Access Compliance Report

Public Rights-of-Way

Intersection ID: 42493	Main Street: REA_RD	Cross Street: TOLLESON_AV	Location: SW
ADA ID: AD9455FAC05A	Ramp Type: Perp	Initial Pass/Fail: Fail	Overall Compliance: No
Severity Score: 8.75			
Codes/Mitigation Info/Possible Solution		Field Measurements/Component Compliance

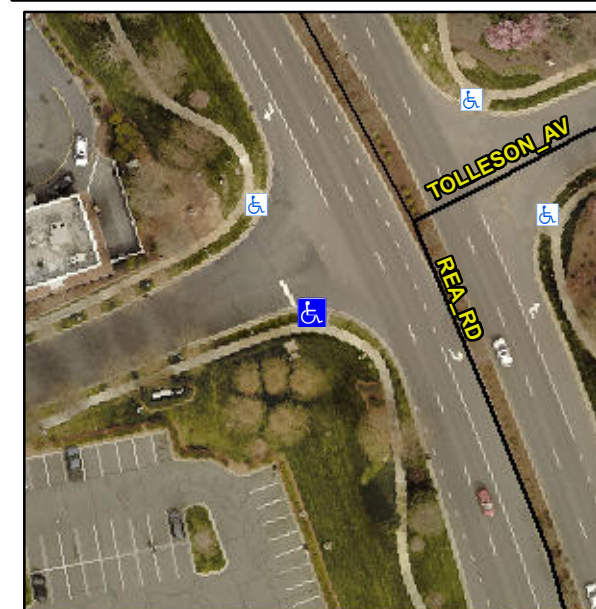
Remove & Replace Entire Ramp.

R304.5.1

Compliance	Description	Data	Compliance	Description	Data
N/A	Ramp Length (in)	72.0	Yes	Ramp Slope (%)	7.4
No	Ramp Width (in)	42.0	Yes	Ramp XSlope (%)	1.5
N/A	Flare Type LT	N/A	N/A	Flare Type RT	N/A
N/A	Flare Slope LT (%)	N/A	N/A	Flare Slope RT (%)	N/A
N/A	Flare Traversable LT?	N/A	N/A	Flare Traversable RT?	N/A
N/A	Landing Length (in)	N/A	N/A	DWS Provided?	N/A
N/A	Landing Width (in)	N/A	N/A	DWS Contrast?	N/A
N/A	Landing Slope (%)	N/A	N/A	DWS Length (in)	N/A
N/A	Landing X Slope (%)	N/A	N/A	DWS Full Width?	N/A
N/A	Landing Curb? (Y/N)	N/A	N/A	DWS Offset (in)	N/A
N/A	Shared Landing?	N/A			
N/A	Gutter Ponding?	N/A	N/A	Gutter Slope (%)	N/A
N/A	Gutter Lip Ht (in)	N/A	N/A	Gutter X Slope (%)	N/A
N/A	Painted X Walk1?	No	N/A	Painted X Walk2?	N/A
	X Walk 1 Direction	To NW		X Walk 2 Direction	N/A
N/A	X Walk 1 Width (in)	N/A	N/A	X Walk 2 Width (in)	N/A
	X Walk 1 Slope (%)	2.4		X Walk 2 Slope (%)	N/A
	X Walk 1 X Slope (%)	2.3		X Walk 2 X Slope (%)	N/A
